Model: General RTB	Date: 4-Feb-03	No.: RGene013b
--------------------	----------------	----------------

Subject: Service remarks at installation		Prepared by: T. Itoh	
From: Technical Service Sec. Service Planning Dept.			
Classification:	☐ Troubleshooting ☐ Part information ☐ Action required		
	☐ Mechanical ☐ Electrical ☐ Service manual revision		
	☐ Paper path ☐ Transmit/receive ☐ Retrofit information		
	☒ Other (Specification change)

Model: Model J-P2 CF		Date: 17-Jun-03	No.: RG367003
Subject: Service Manual Revision		Prepared by: H.Taguchi	
From: 1st Tech. Support Sec. Service Support Dept.			
Classification:	☐ Troubleshooting ☐ Mechanical ☐ Paper path ☐ Other ()	☐ Part information ☐ Electrical ☐ Transmit/receive	☐ Action required ☒ Service manual revision ☐ Retrofit information

Model: Model J-P2 CF		Date: 24-Mar-04	No.: RG367004
Subject: SC142 due to defective CCD		Prepared by: H.Taguchi	
From: 1st Tech. Support Sec. Service Support Dept.			
Classification:	☒ Troubleshooting ☐ Mechanical ☐ Paper path ☐ Other ()	☐ Part information ☐ Electrical ☐ Transmit/receive	☐ Action required ☐ Service manual revision ☒ Retrofit information

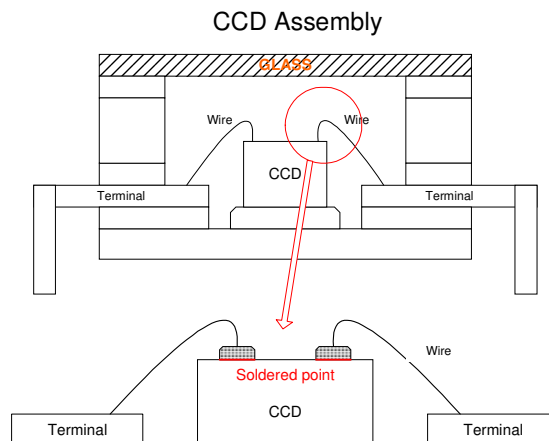
- SC142 (White Level Detection Error)
- SC101 (Exposure Lamp Error)
- Colored vertical lines/bands/background (see photo).

The adhesive used to attach the glass to the CCD assembly was changed, but it generated a gas when exposed to the heat from the PCB during machine operation. The gas caused the soldered points of wires on the CCD to oxidize and deteriorate, resulting in poor contact.

The adhesive has been changed back to the original type.

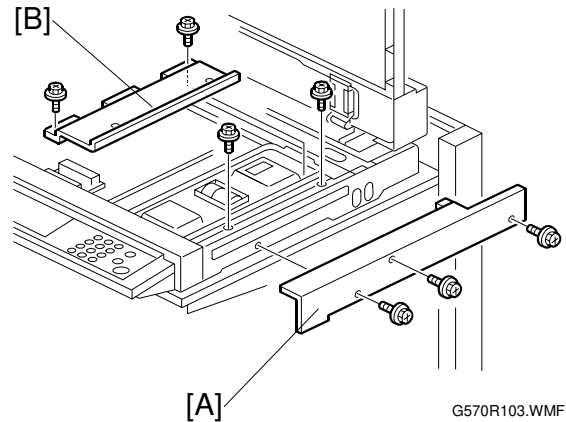
Retrofit parts (lens block assemblies) will be provided to the field FOC for all affected units. Therefore, at the next service visit or when the issue is reported, please replace with P/N B1169455.

- This retrofit part is the same part as normal service parts P/N G5702930.
- The replacement procedure appears on the following page.
- If SC101 or SC142 should recur after installing the new lens block assembly, please check the xenon lamp (referring to MB #MG570005 and #MG367001) and replace this part if necessary.

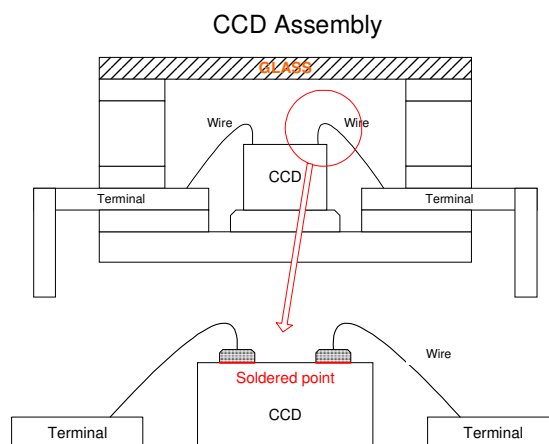
- SC142 (White Level Detection Error)
- SC101 (Exposure Lamp Error)
- Colored vertical lines/bands/background (see the photo).

The adhesive used to attach the glass to the CCD assembly was changed, but it generated a gas when exposed to the heat from the PCB during machine operation. The gas caused the soldered points of wires on the CCD to oxidize and deteriorate, resulting in poor contact.

The adhesive has been changed back to the original type.

6. Lens block assembly (Sensor board unit) [C] (⌀ x 4, ⌀ x 4)

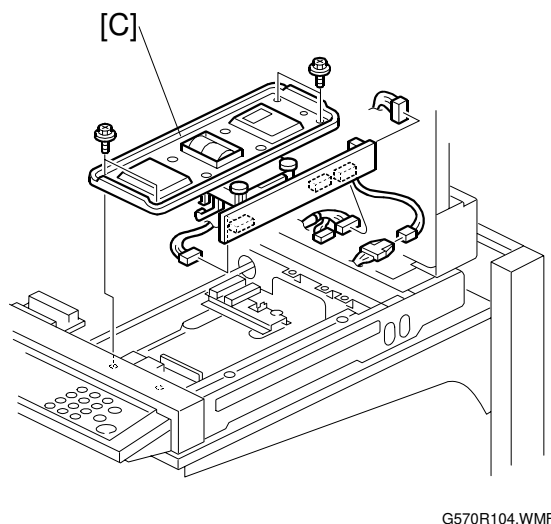
7. After replacing the lens block assembly (Sensor board unit), **check that the current setting of SP4-205 (Black ADS Level) is at its default of 70.**
 - ***If this SP is at a value of 8, this can cause incorrect background detection in ADS mode and lead to dirty background.***
8. Adjust the following SP modes according to the following scanner adjustment procedure.
 - SP4-008 (Scanner leading edge magnification)
 - SP4-010 (Scanner leading edge registration)
 - SP4-011 (Scanner side-to-side registration)
